Re: **Seventh (Technical) Submission Review –** **Porteos** (Infrastructure CSP)  
Application Number: **DA-1903-13**  
Case Number: **2019-6032-00**

Thank you for taking the time to review our seventh submission of Porteos Phase 5 Powhaton ISP. We received your comments on May 8, 2020. Responses to comments have been provided below. The following items have been included in the resubmittal:

## Seventh Submission Review

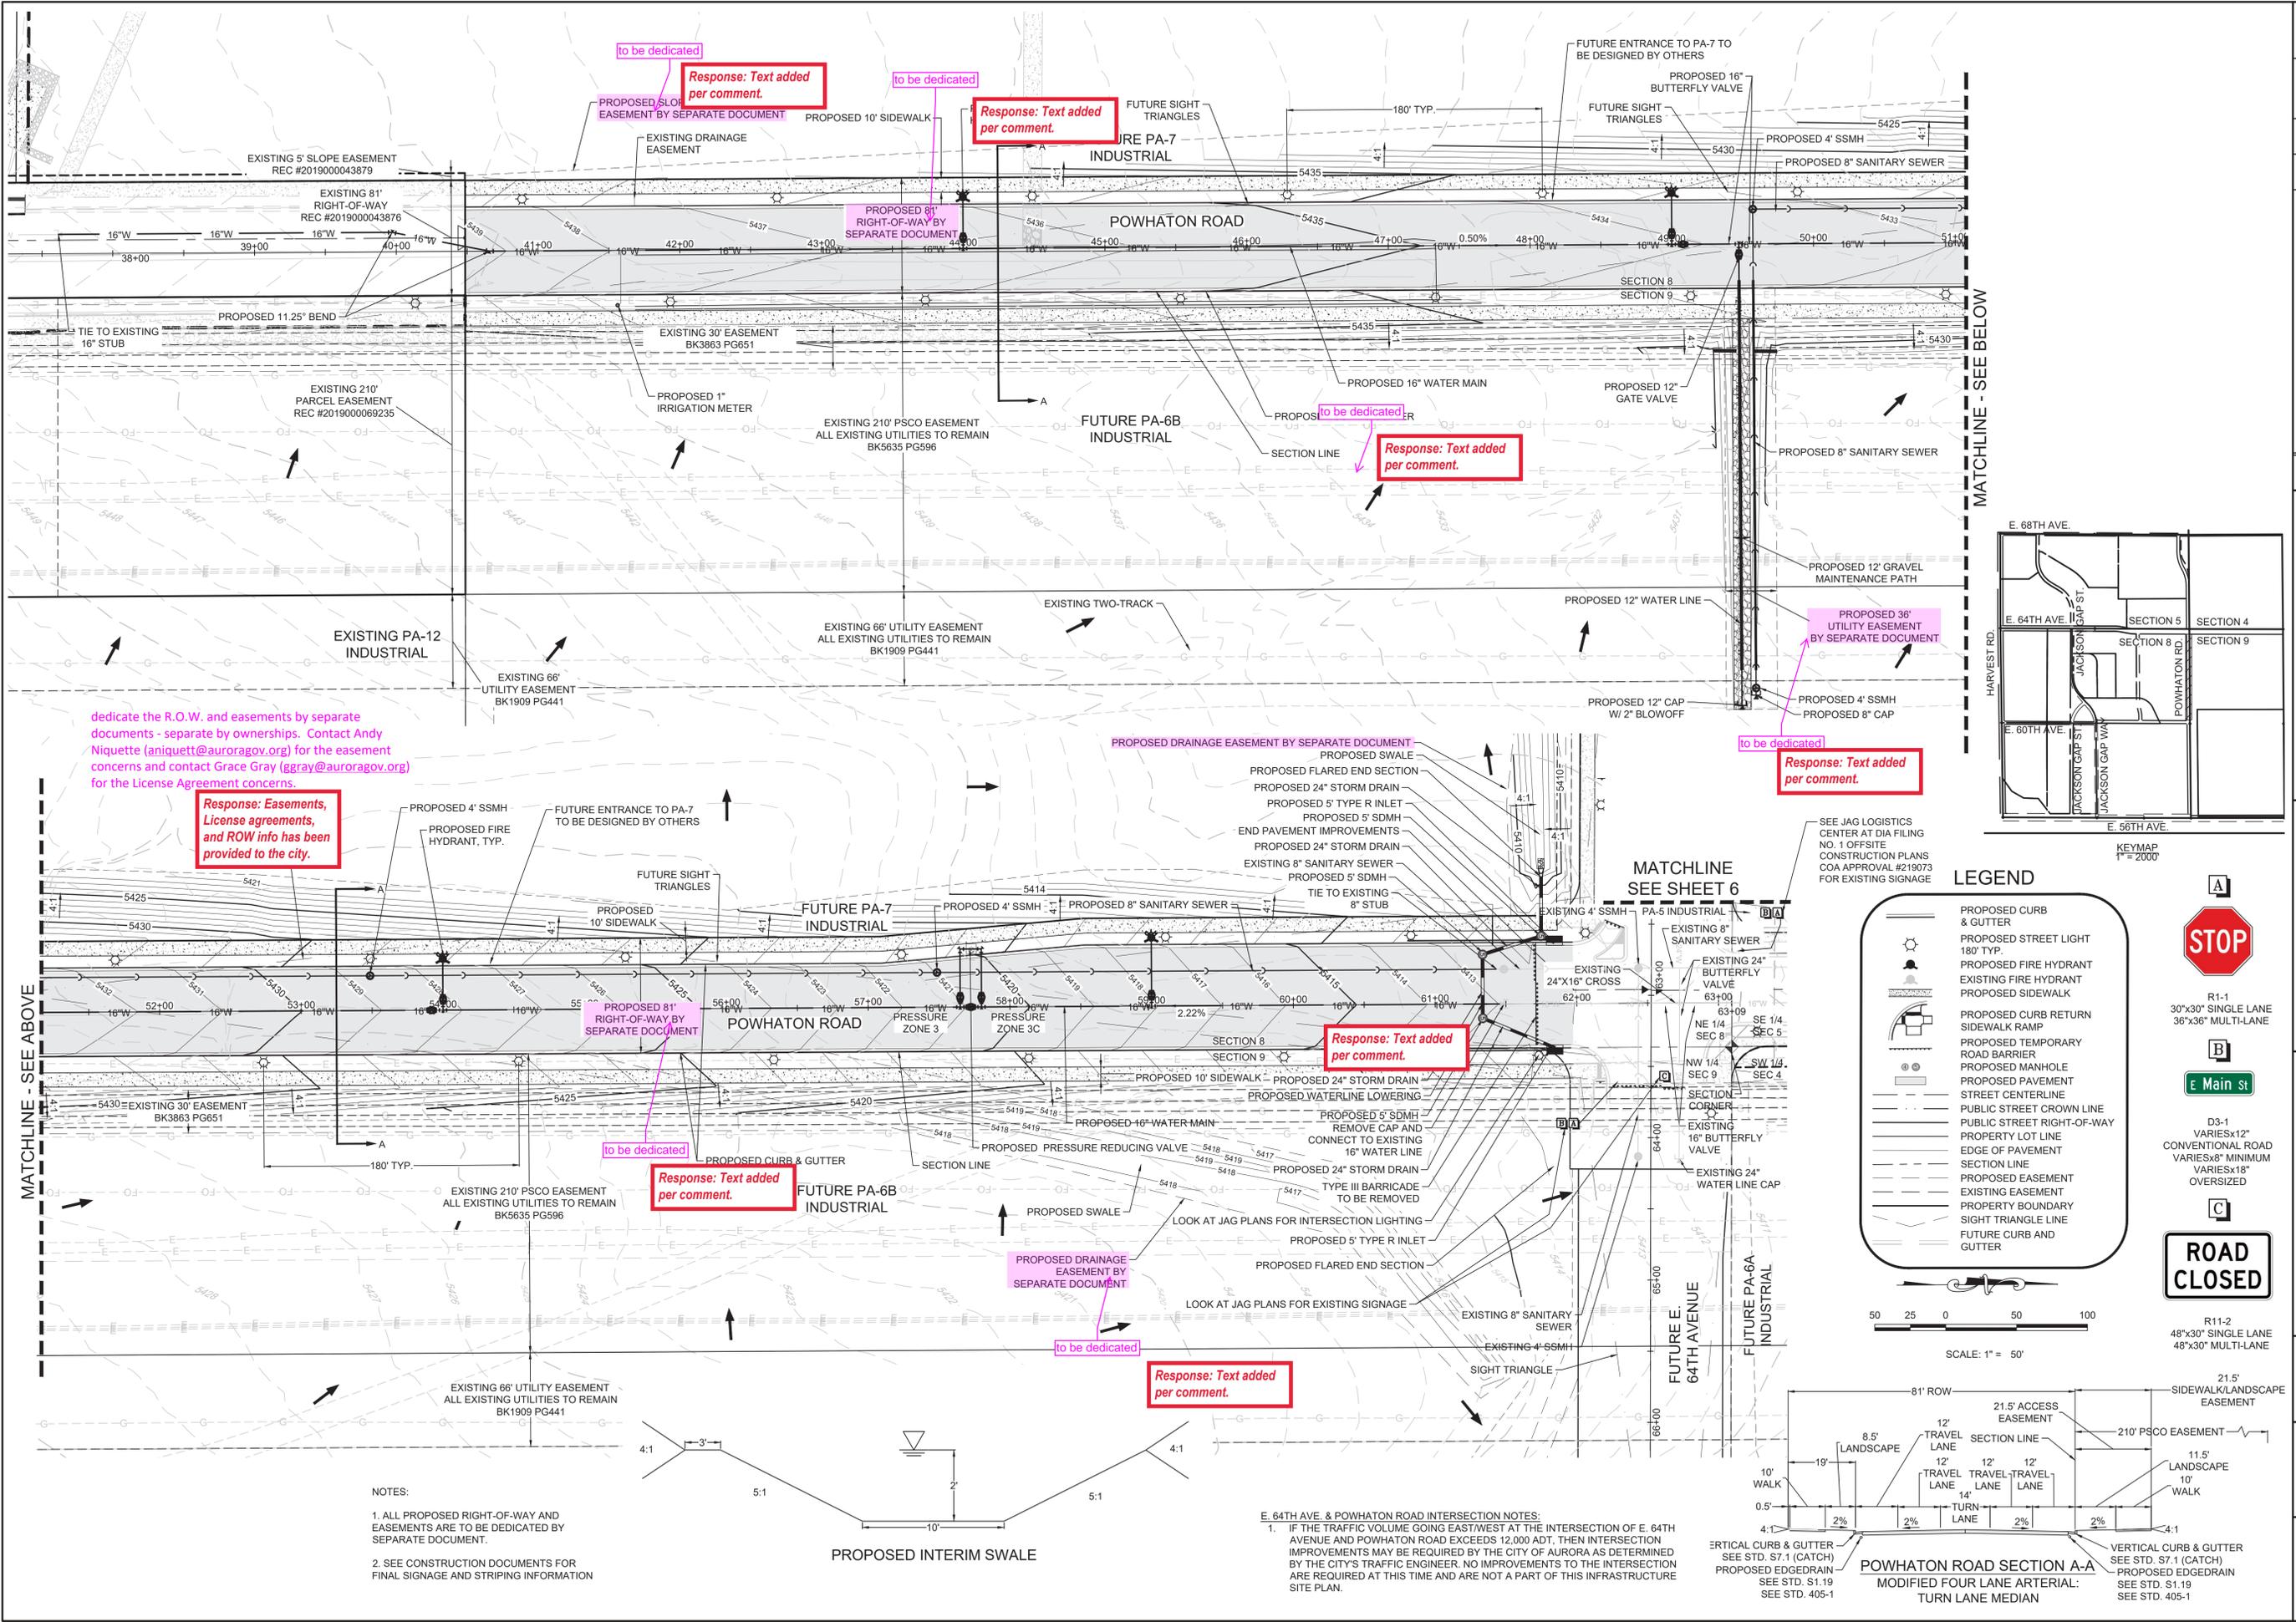
dedicate the R.O.W. and easements by separate documents - separate by ownerships. Contact Andy Niquette (aniquette@auroragov.org) for the easement concerns and contact Grace Gray (gray@auroragov.org) for the License Agreement concerns.

**Response: Easements, License agreements, and ROW info has been provided to the city.**

**Response: Text added per comment.**

PORTEOS - PHASE 5  
 INFRASTRUCTURE SITE PLAN  
 E. 64TH AVENUE PLAN VIEW

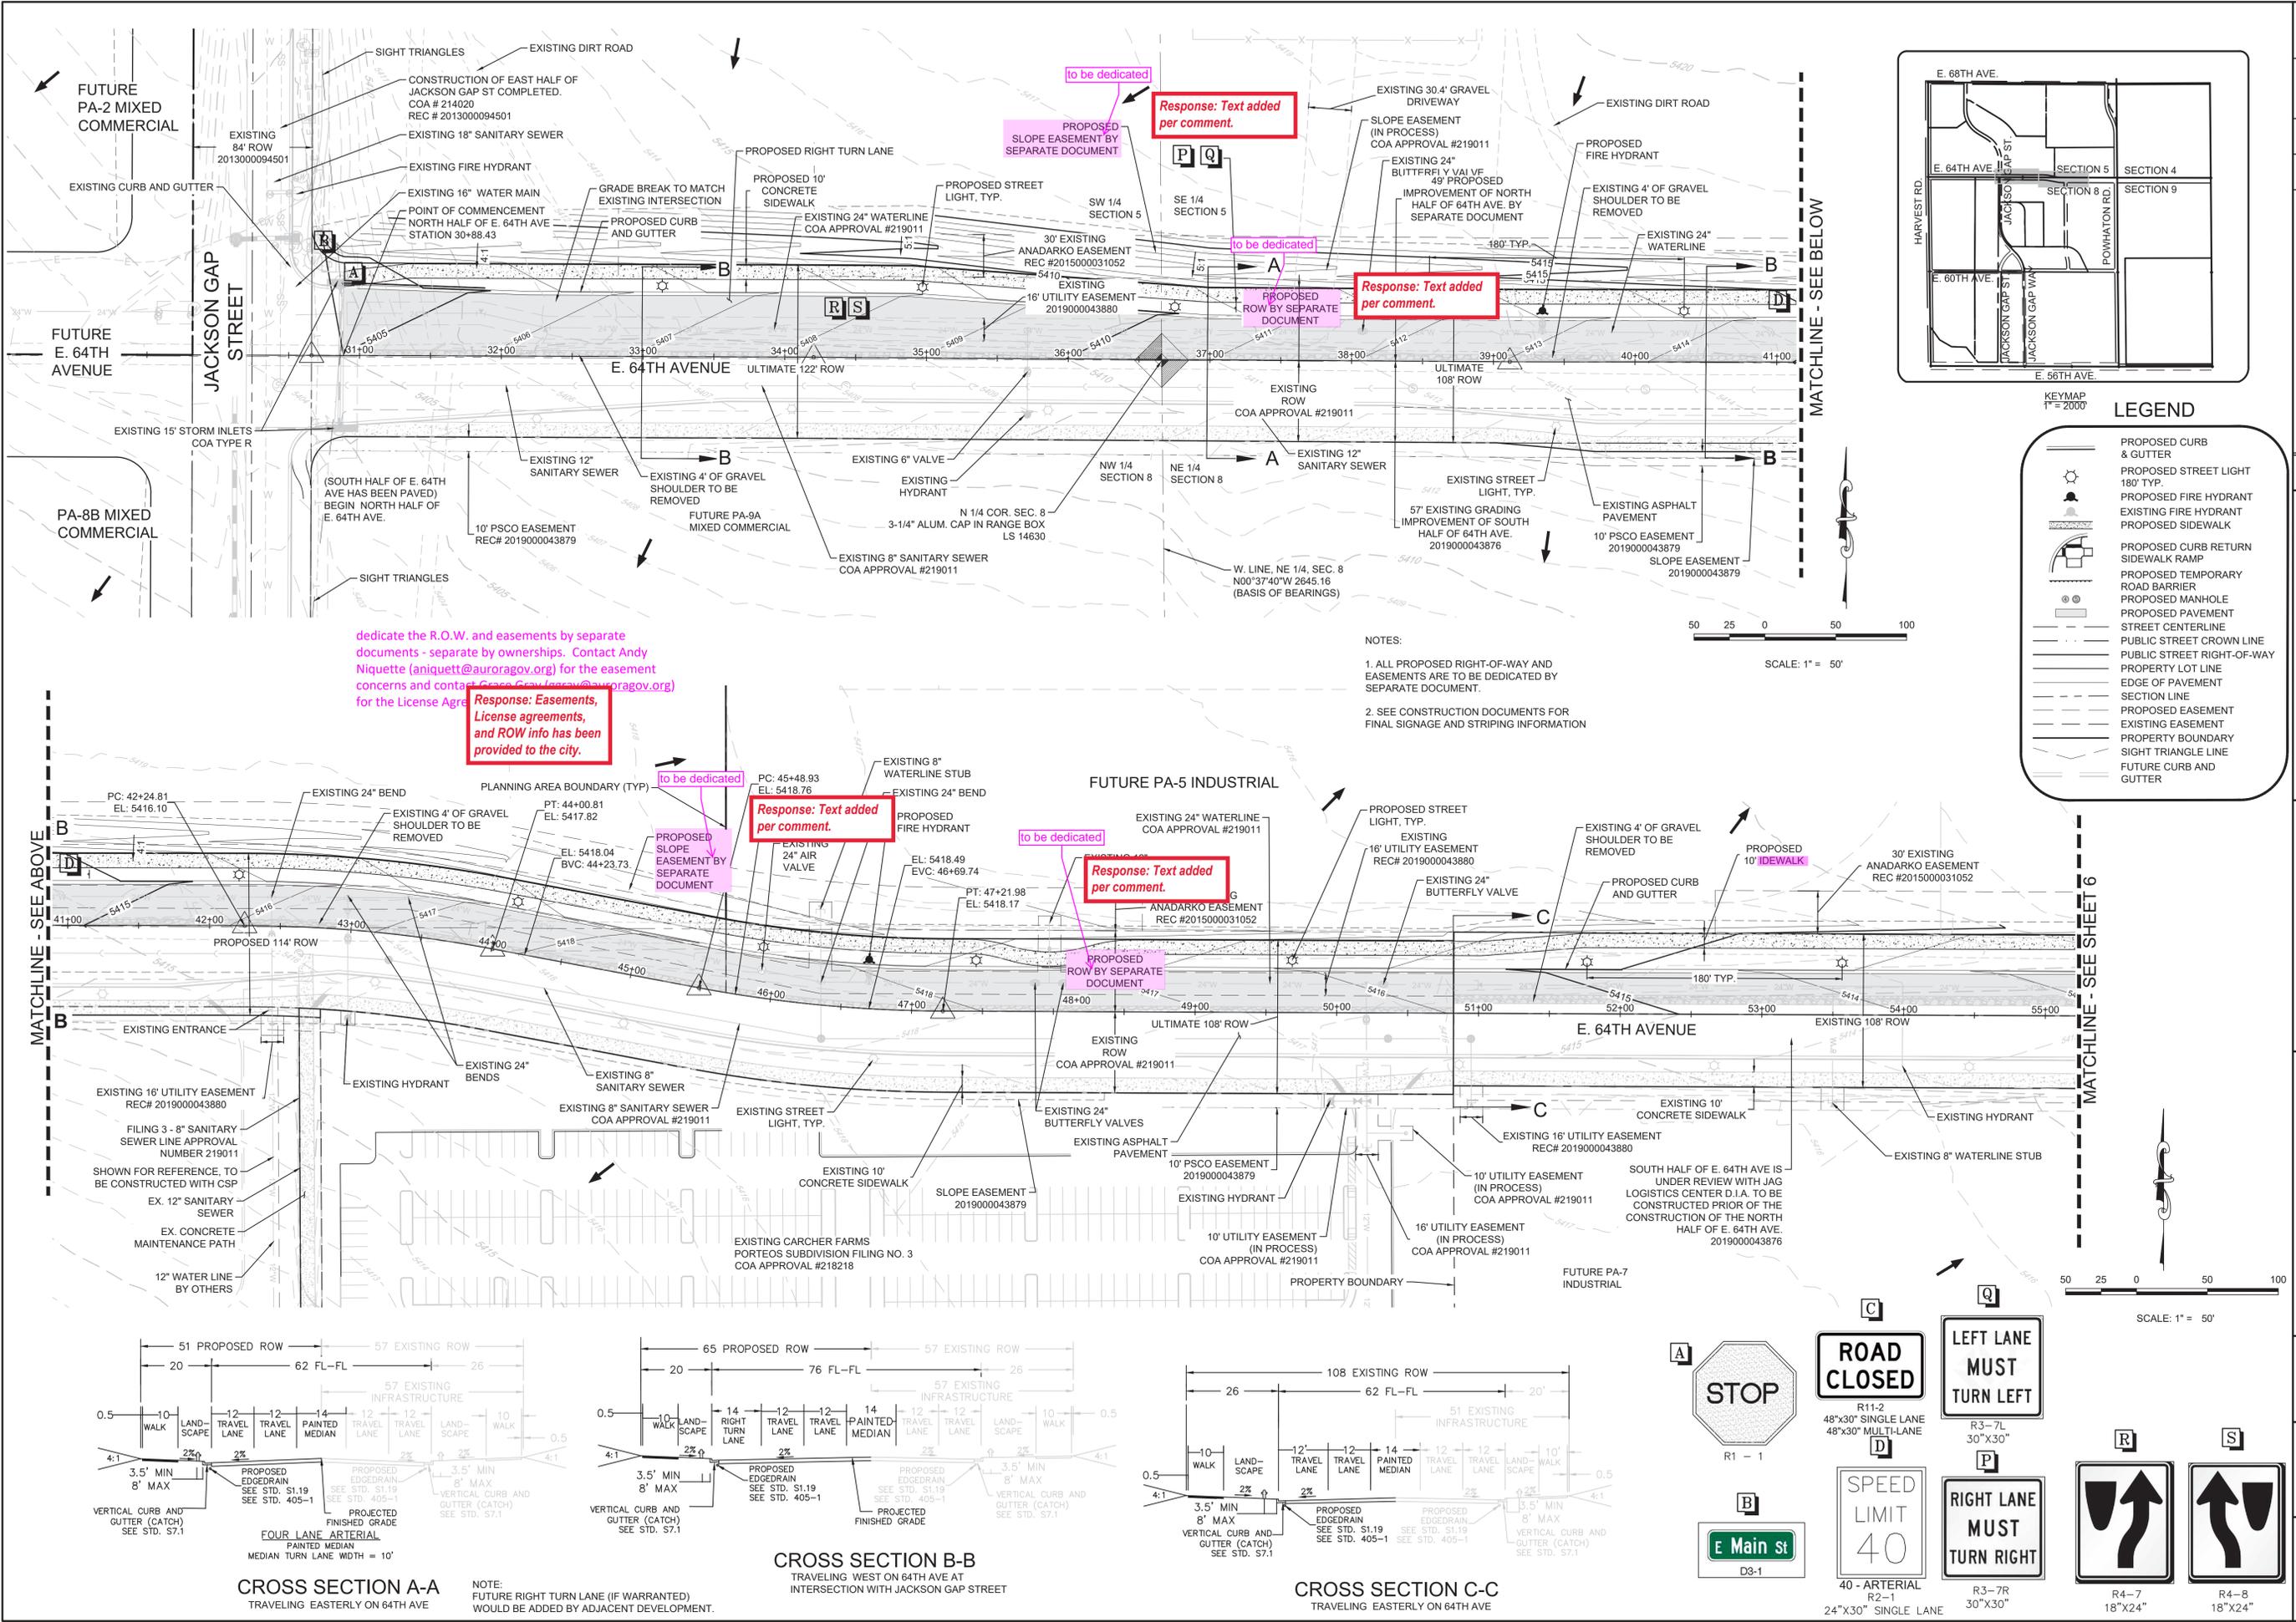
dedicate the R.O.W. and easements by separate documents - separate by ownerships. Contact Andy Niquette (aniquette@auroragov.org) for the easement concerns and contact Grace Gray (gray@auroragov.org) for the License Agreement.

Response: Easements, License agreements, and ROW info has been provided to the city.

Response: Text added per comment.

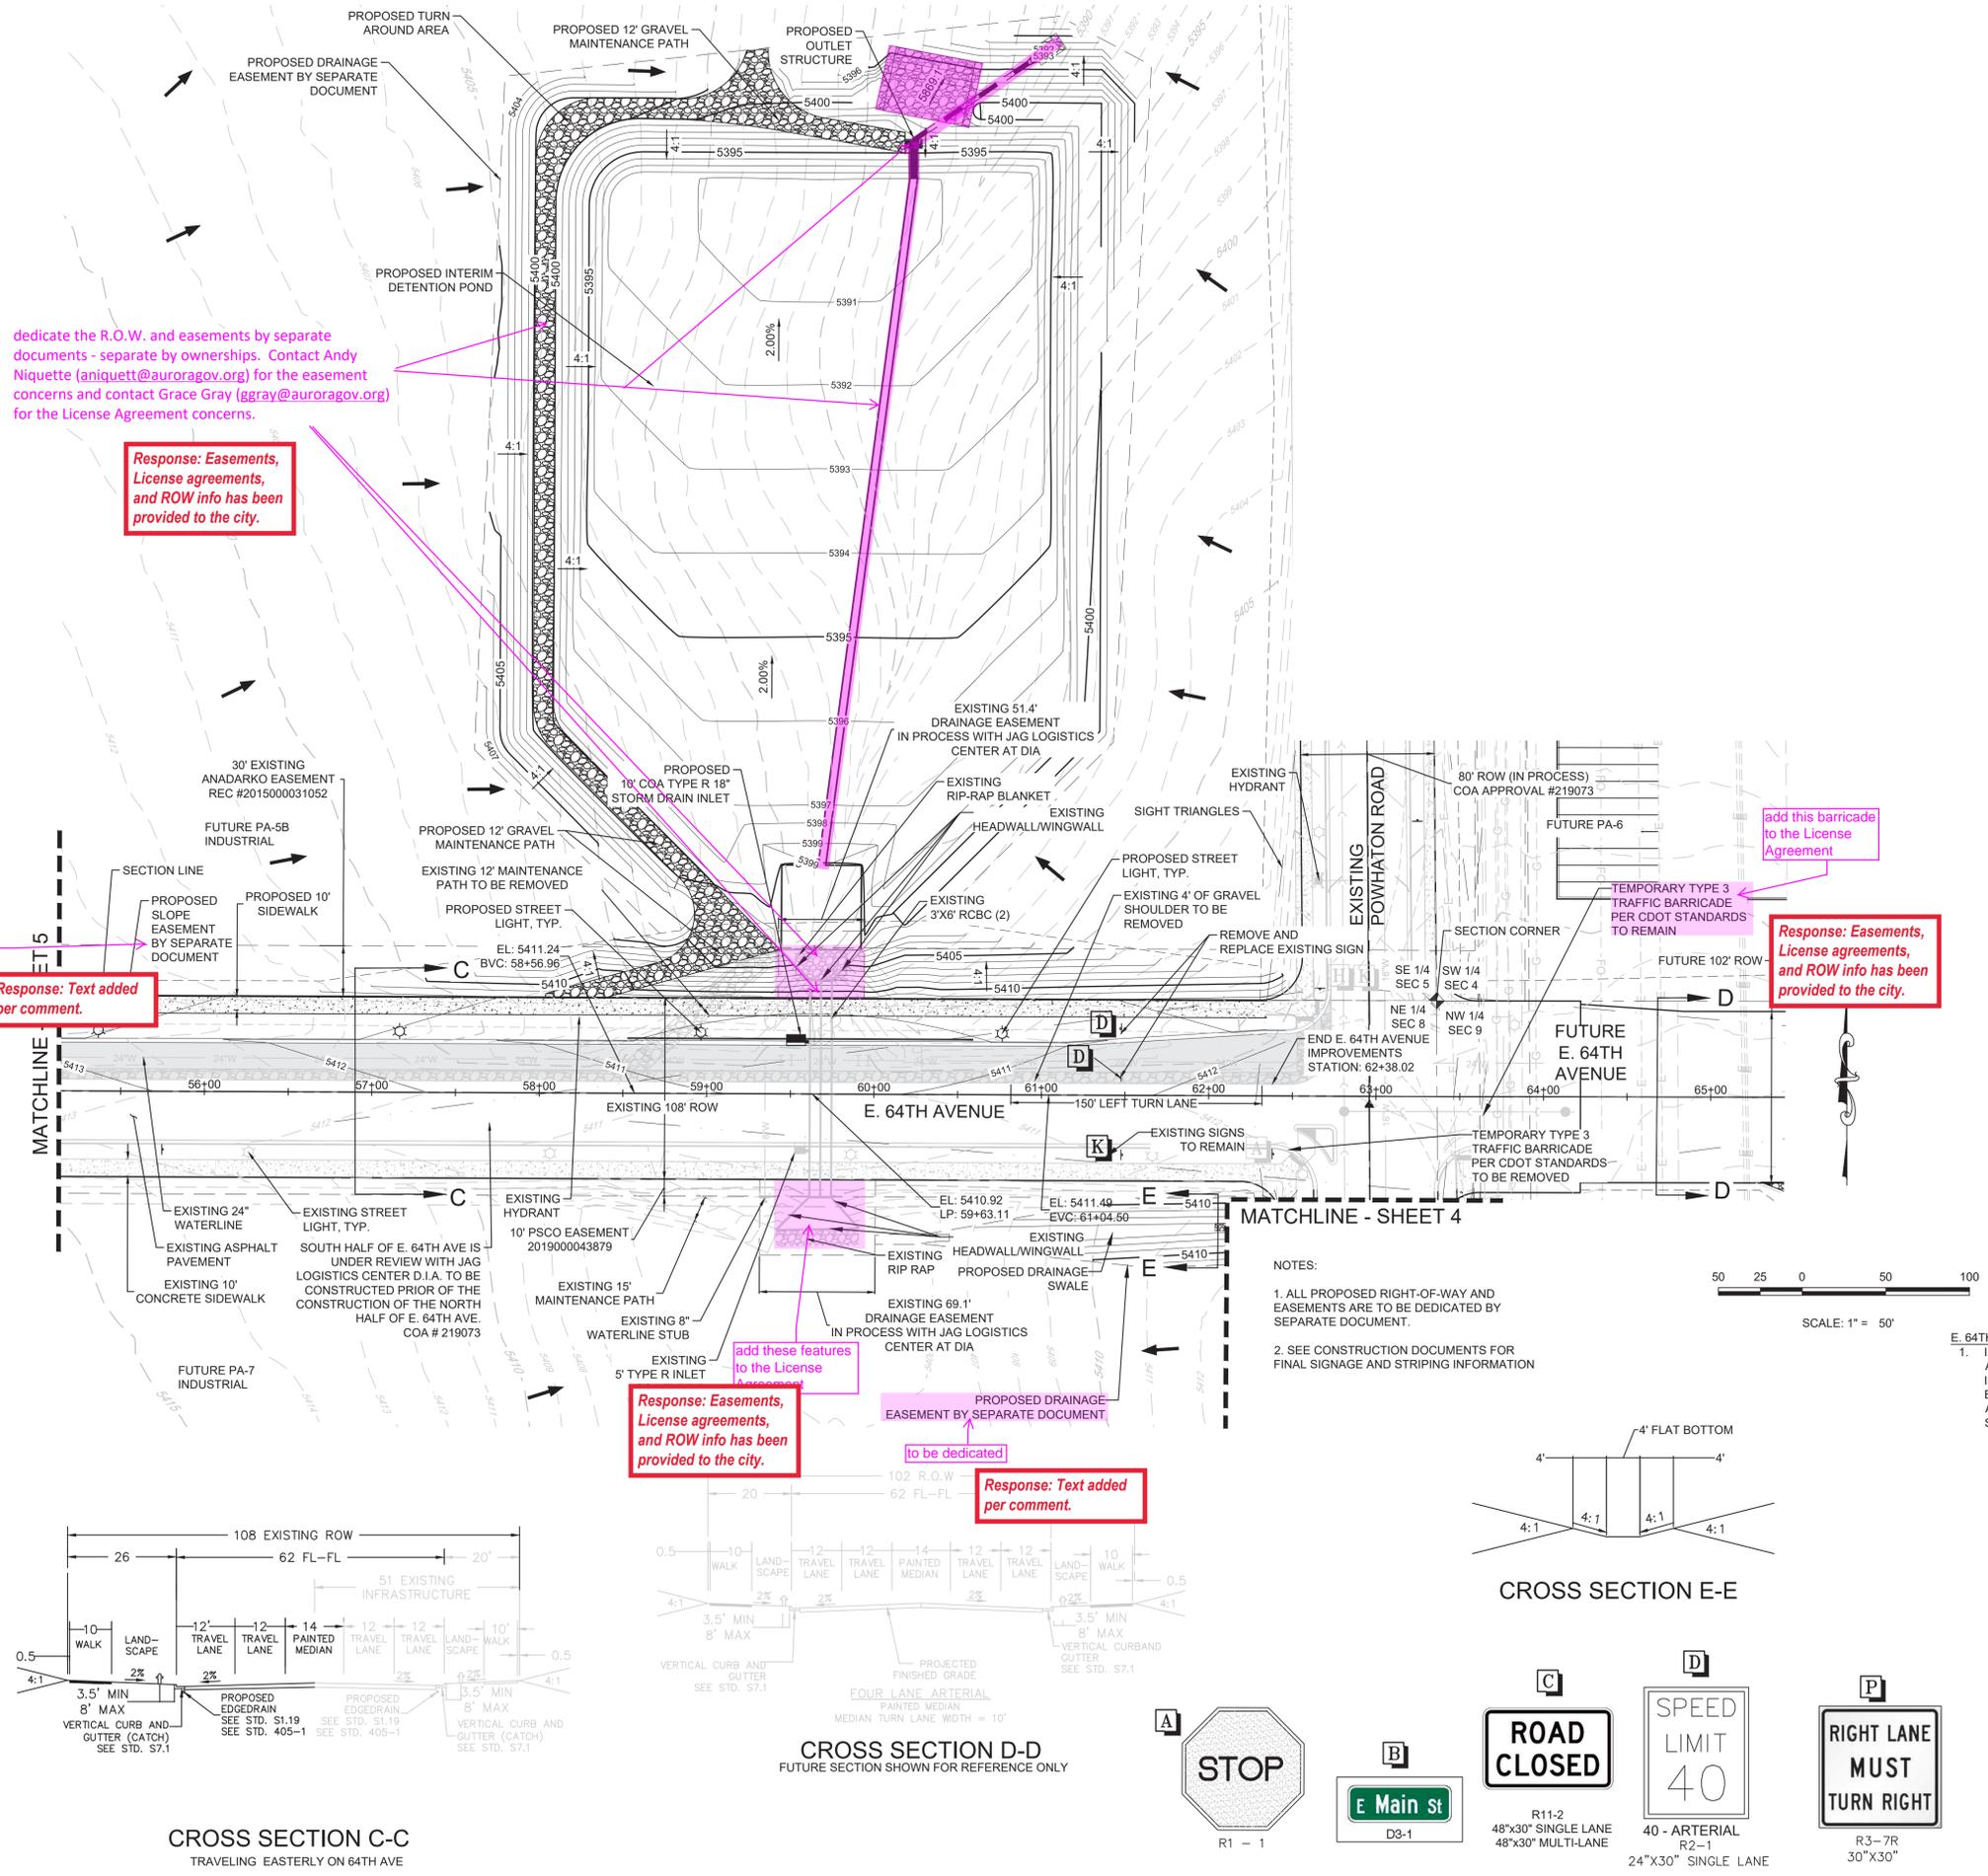
dedicate the R.O.W. and easements by separate documents - separate by ownerships. Contact Andy Niquette (aniquette@auroragov.org) for the easement concerns and contact Grace Gray (ggray@auroragov.org) for the License Agreement concerns.

**Response: Easements, License agreements, and ROW info has been provided to the city.**

**Response: Text added per comment.**
